Reviewed by City Planner

Revisions Required

RESIDENCE AT SOUTH HAVEN FARMS

SITE PLAN	JOB NO. 3-19-028
PAYSON CITY, UTAH	SHEET NO. 2

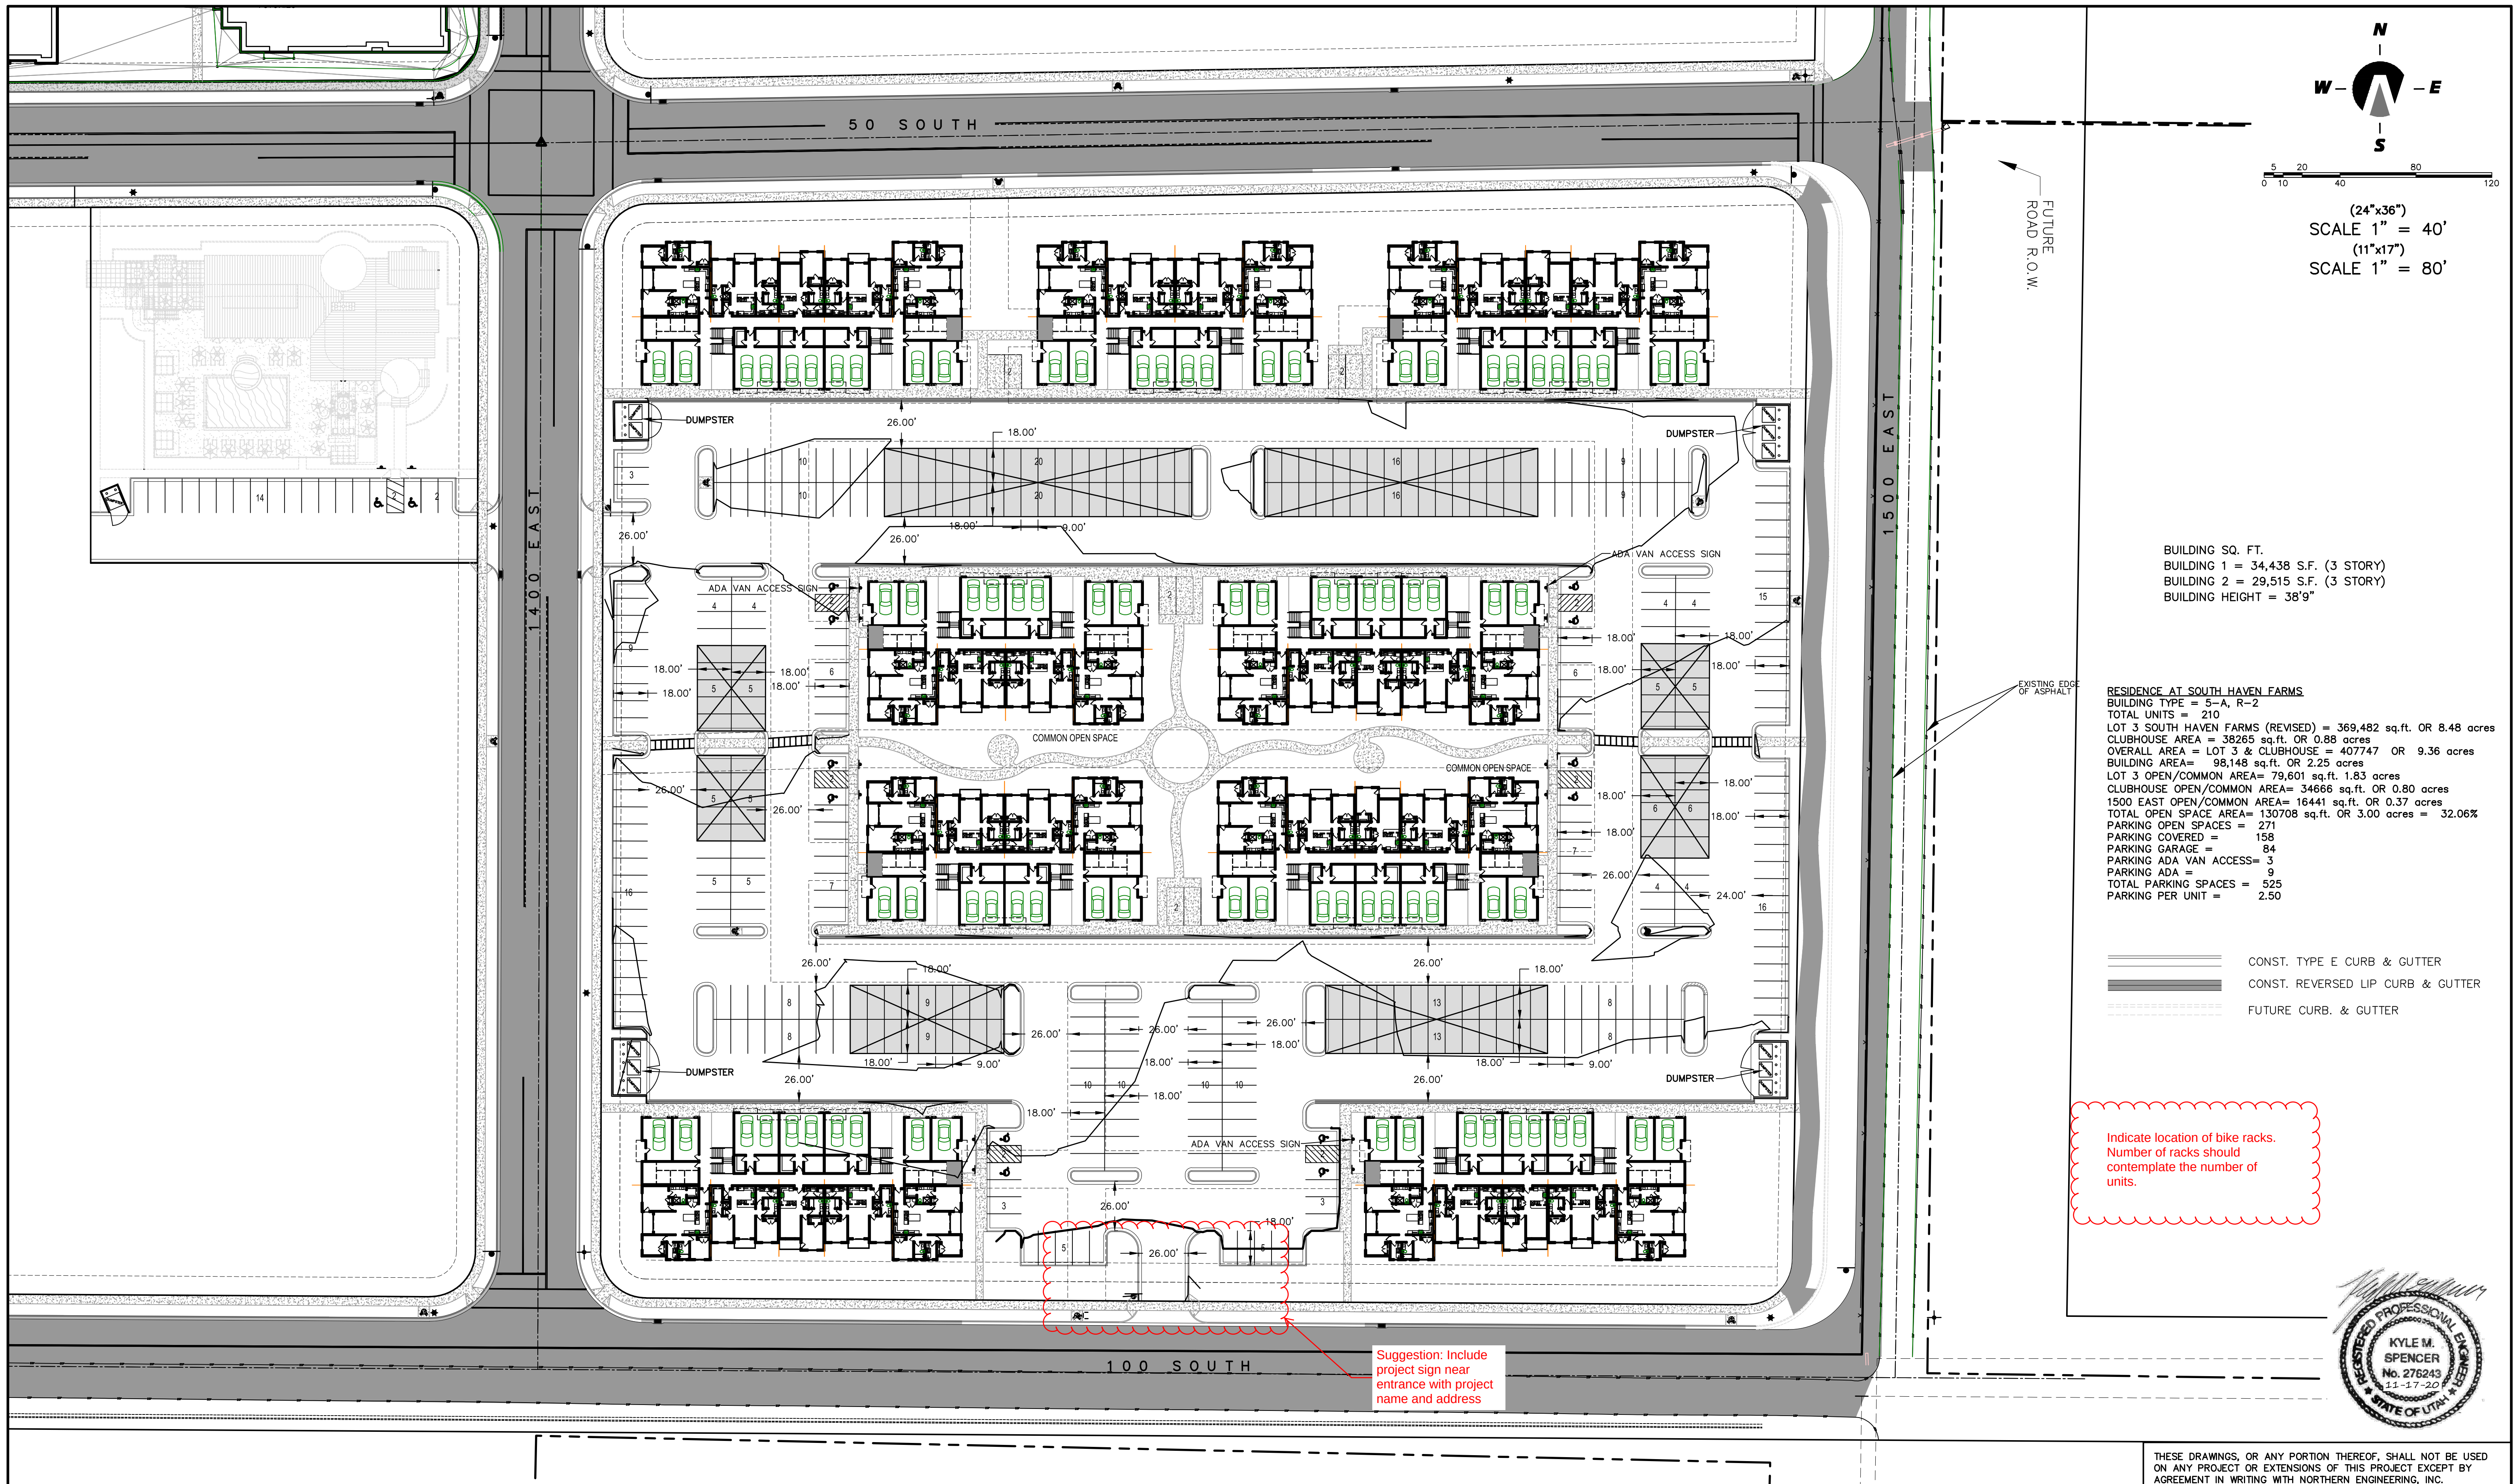
1. Approvals: Preliminary and Final Development Plan;
waiver of RV parking; amenity package; development agreement
2. Final approval items:

a. Prepare and record easements (i.e. water line)

b. Development agreement

c. Payment of property taxes

d. Transfer of water

e. Performance guarantee

f. Payment of fees, including electrical invoice and testing and inspection

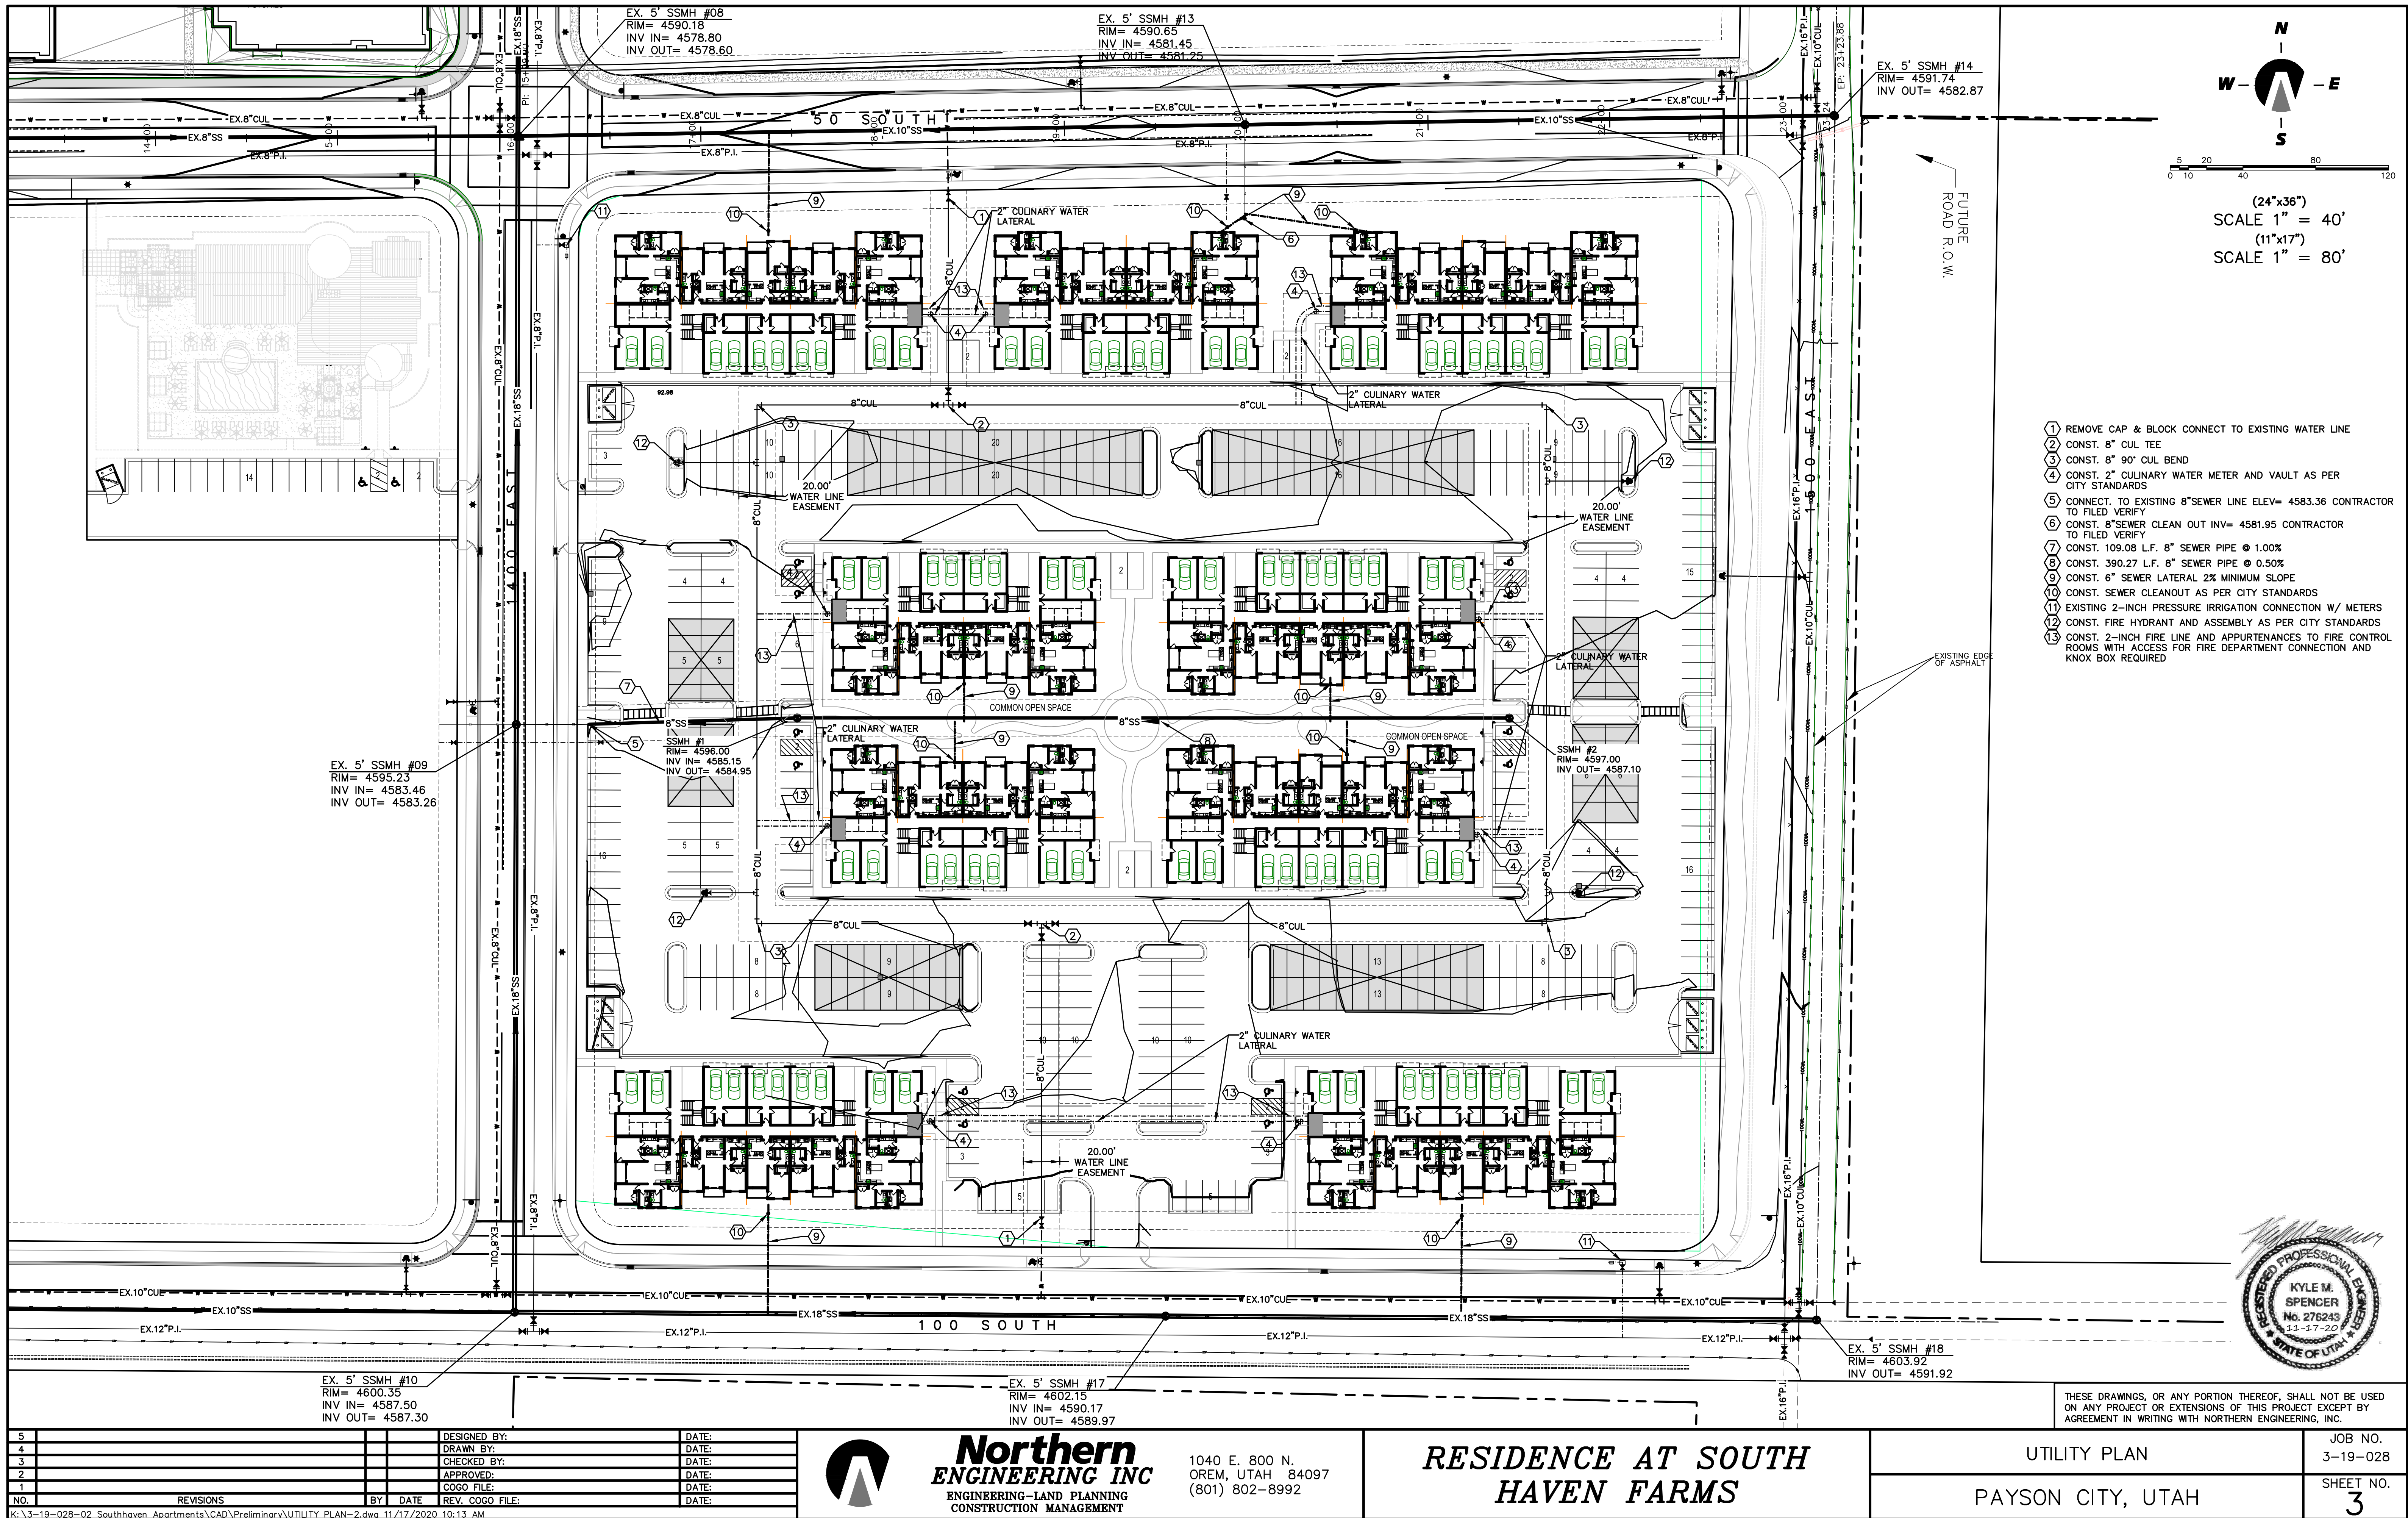
Indicate location of bike racks.
Number of racks should
contemplate the number of
units.

Suggestion: Include
project sign near
entrance with project
name and address

SHEET NO.
AAP-01

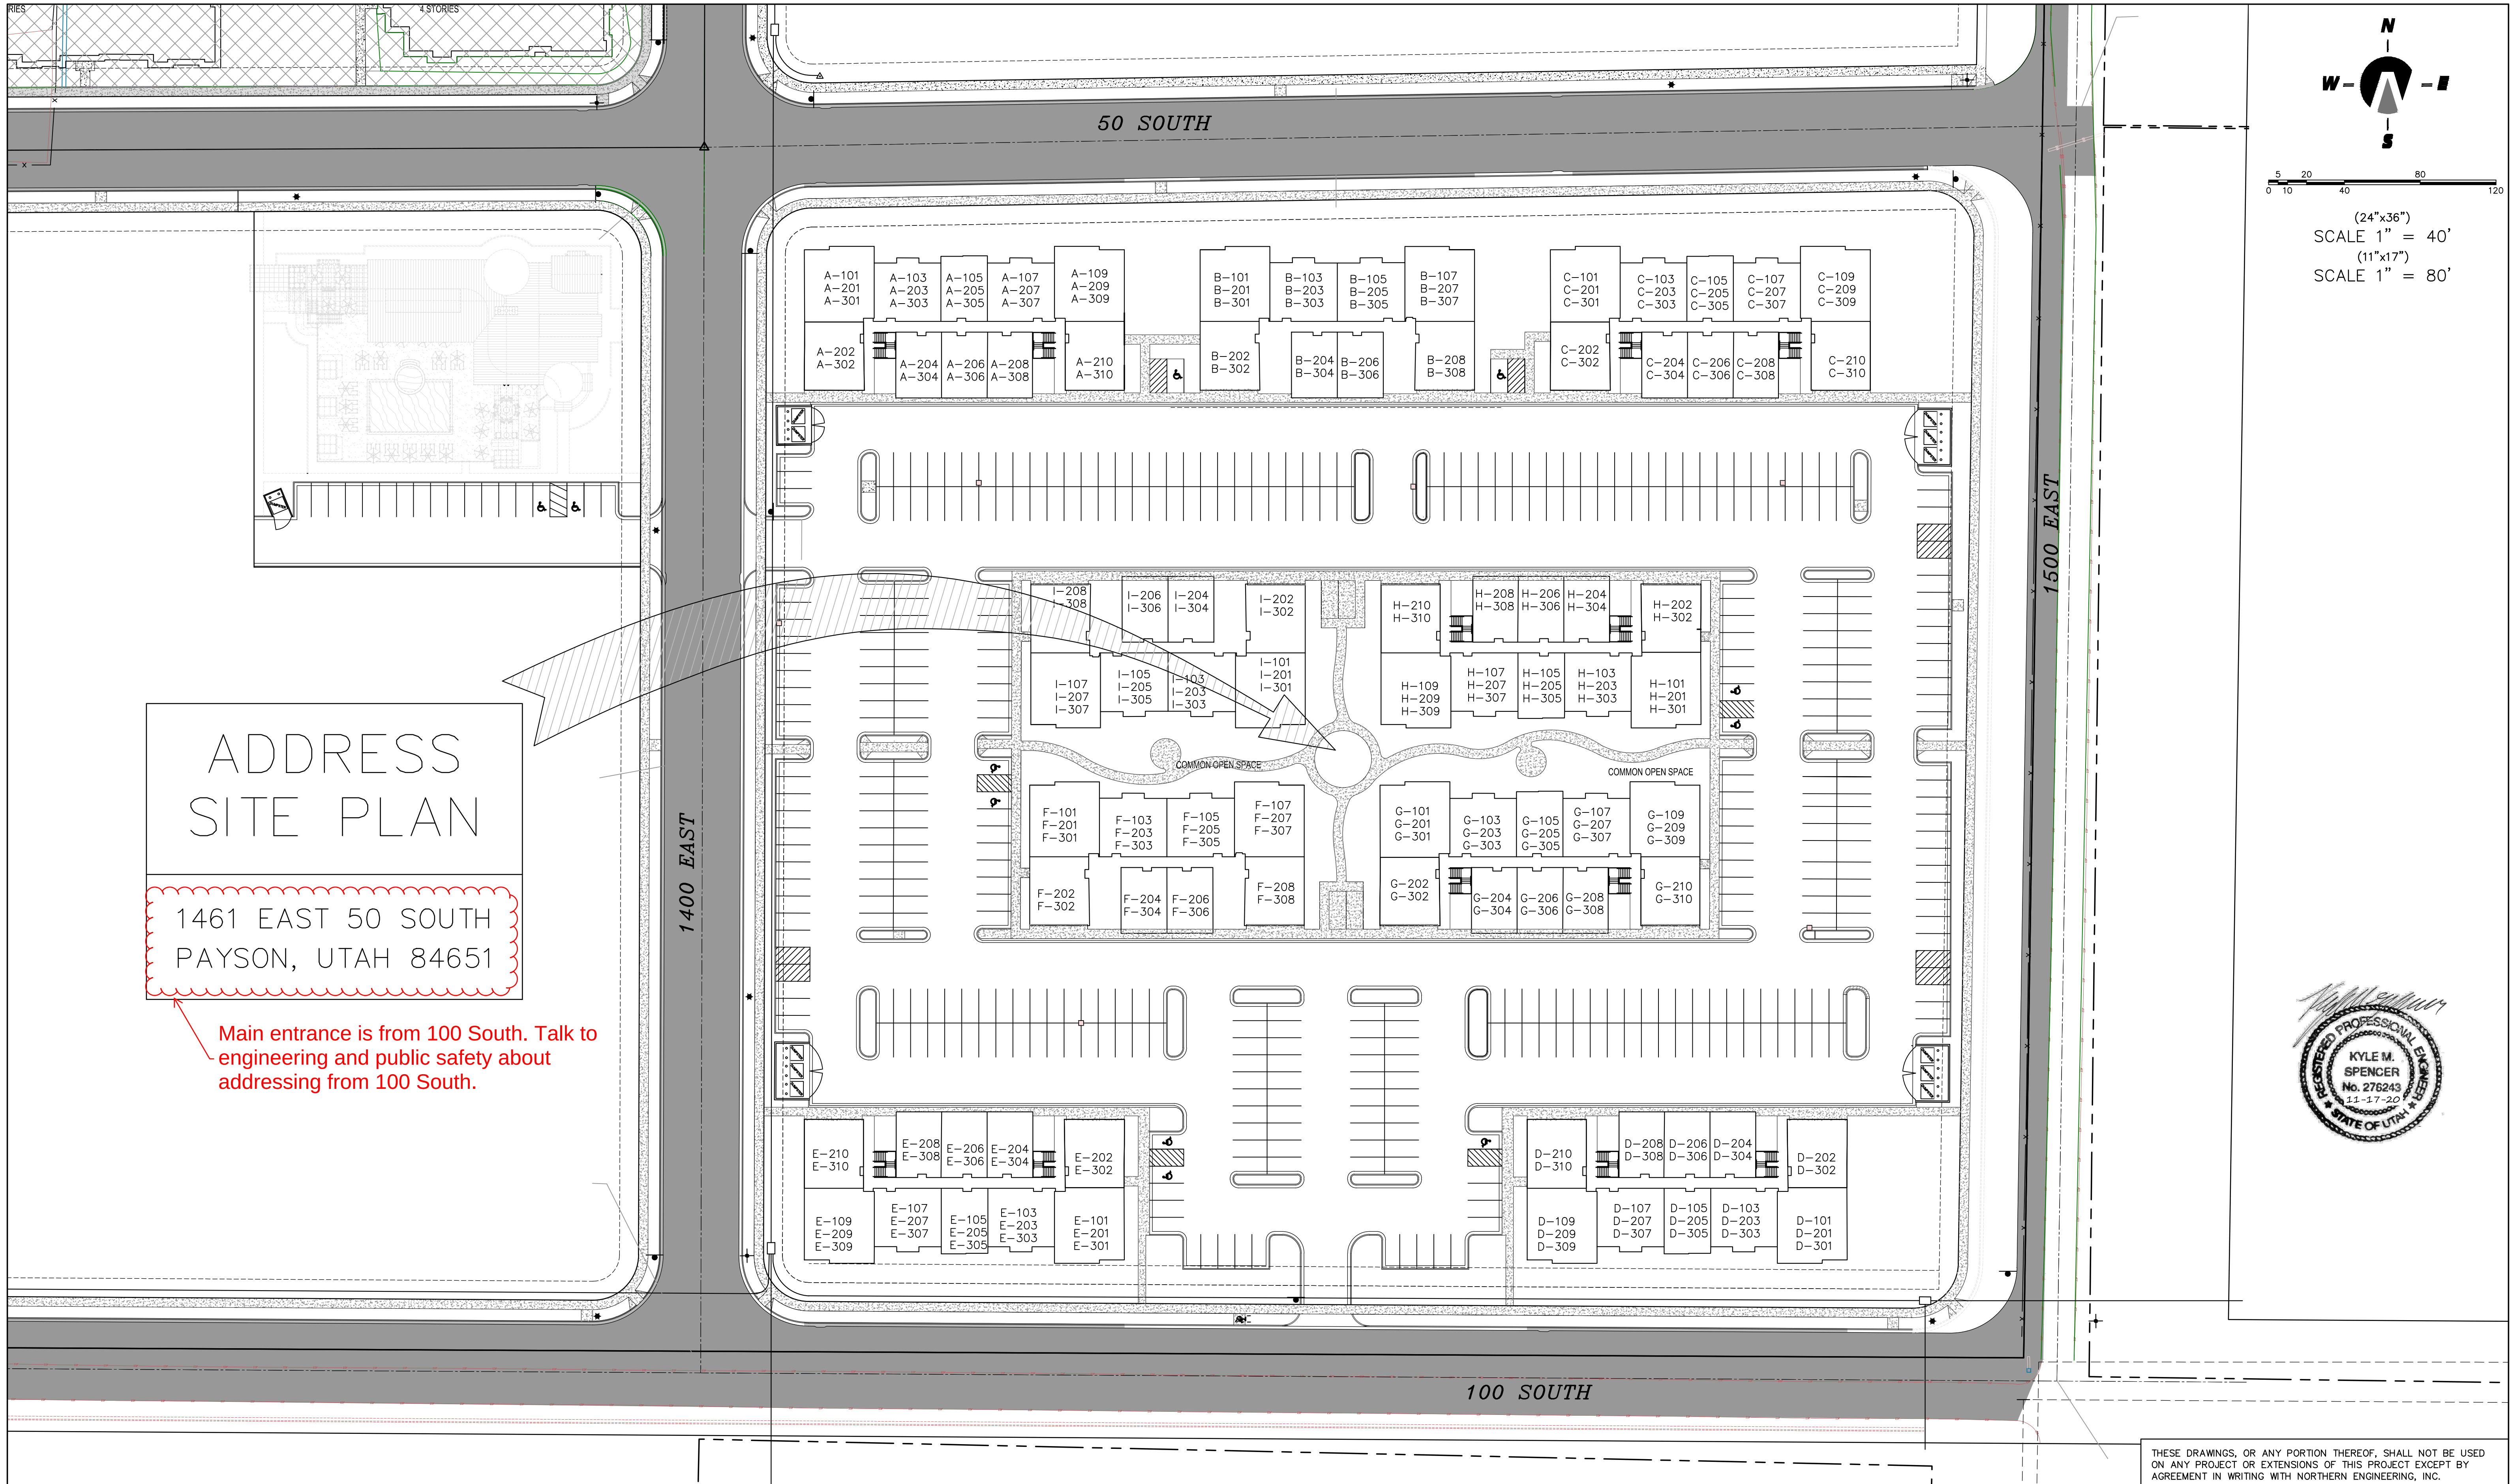
Provide information on address detail for each building.
